DRAINAGE AND TRANSPORTATION INFORMATION SHEET (REV 6/2018)

LOT 2, BLOCK 5
UNSER CLIFFS SUBDIVISION

QUALITY BUILDERS - MARTINEZ - LOT 2 GRADING & DRAINAGE PLAN

RE: **Lot 2 Block 5, Unit 5, S.A.D. 227**
Volcano Cliffs Subdivision
6520 Onyx Ct. NW
Grading and Drainage Plan
Engineers Stamp Date: 12/30/19 (E10D072)
Pad Certification Date: 1/29/20

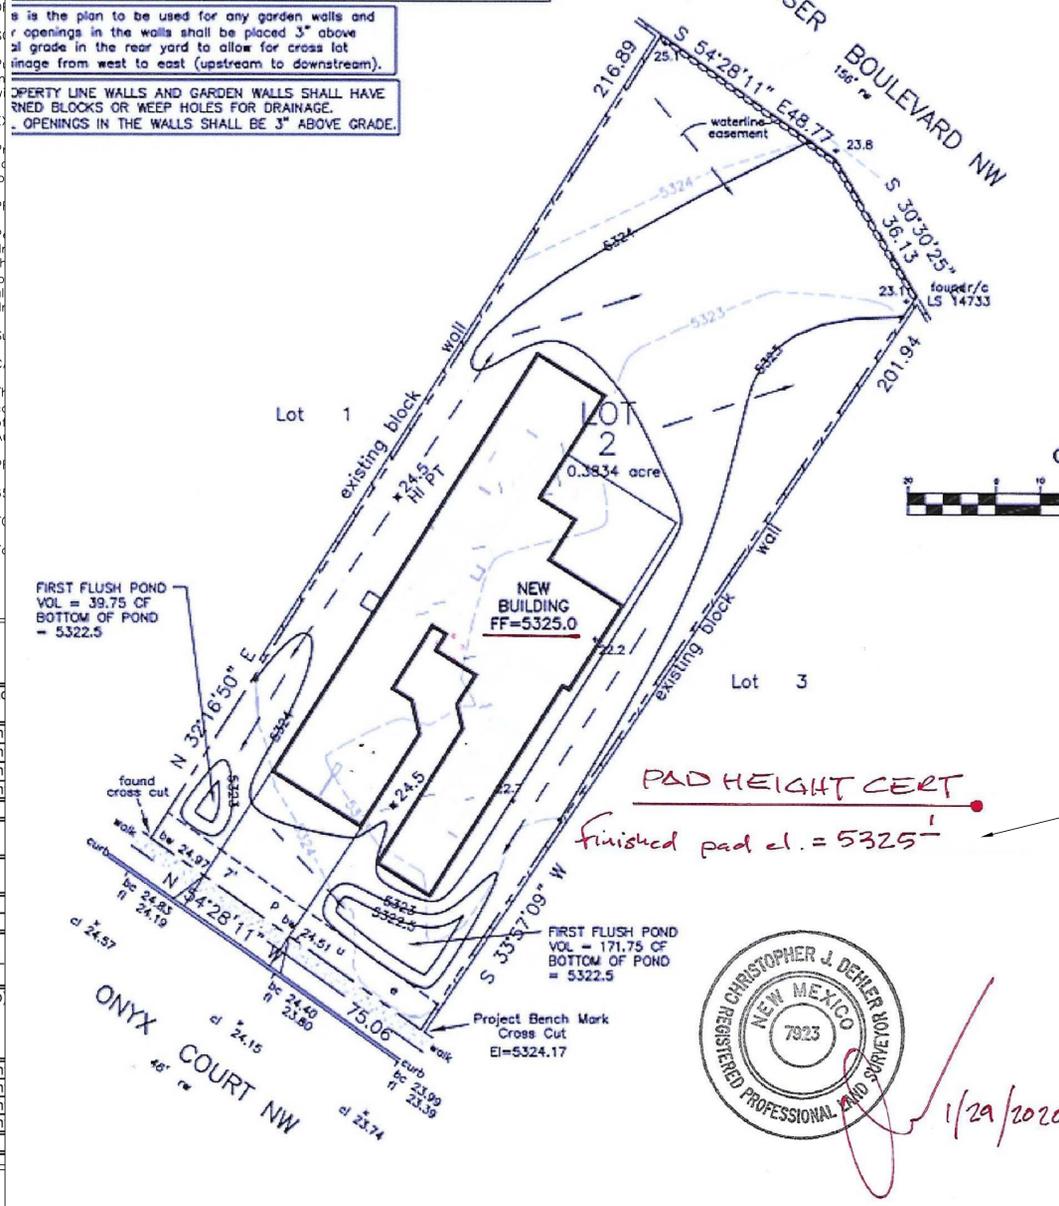
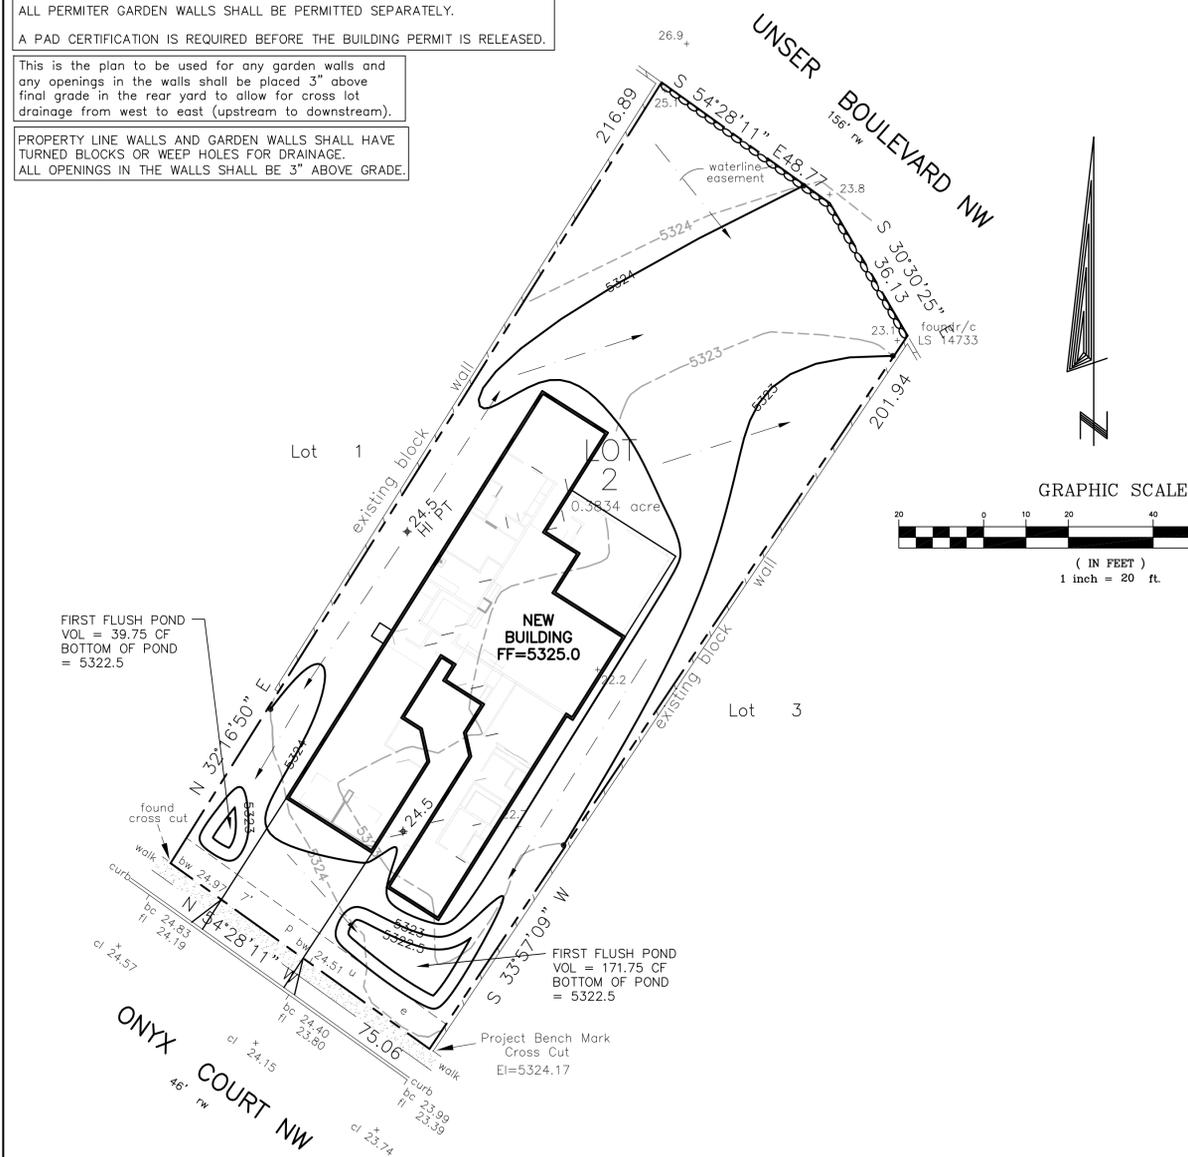
Based upon the information provided in your submittal received 2/7/20, this plan is approved for Building Permit.

Reiterate to the Owner/Contractor that a separate permit for any garden/retaining wall must be obtained, with the approved G&D plan dated 12/4/18.

Prior to Certificate of Occupancy release, Engineer Certification per the DPM checklist of this plan will be required. A fee of \$75.00 will be charged for this certification. If an additional resubmittal is required a \$75.00 fee for each resubmittal will be charged.
